PROTERRA

TECHNICAL SERVICE BULLETIN

ISSUE DATE:	1-4-2022
SERVICE BULLETIN SUBJECT:	Steering Gearbox Valve Housing Torque Retrofit
VINs or MODELS AFFECTED:	Service Specified Buses
COMPLETE BY:	Next Service Opportunity
SERVICE BULLETIN #:	SC-22-1
Labor Operation Code:	SC51Z

STEERING GEARBOX VALVE HOUSING TORQUE RETROFIT

Steering
Gearbox
Housing

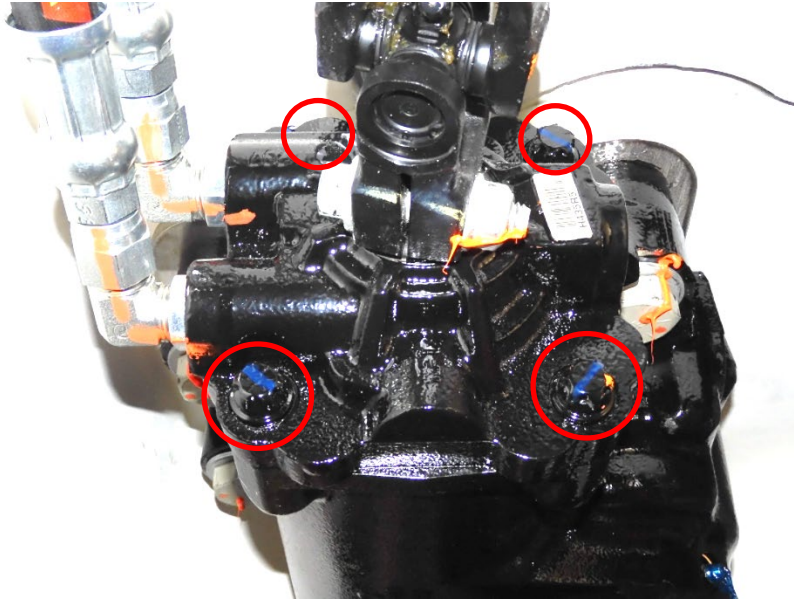
3. Working safely underneath the bus, access the Steering Gearbox Housing shown in the following photograph.

4. Using a Ratchet with an E18 Torx Socket, loosen one of the four Torx bolts shown circled in red in the following photograph.

5. Using a Calibrated Torque Wrench with an E18 Torx Socket, **torque the bolt to 118 foot-pounds.**
6. Using Orange Torque Stripe Paint, mark the properly torqued bolt.
7. Repeat the process to properly torque and mark the remaining three (3) bolts.
8. Remove the four (4) Jack Stands.
9. Lower the bus using the four (4) Wheel Lifts.
10. Remove the Lockout/Tagout devices and return the bus to service.
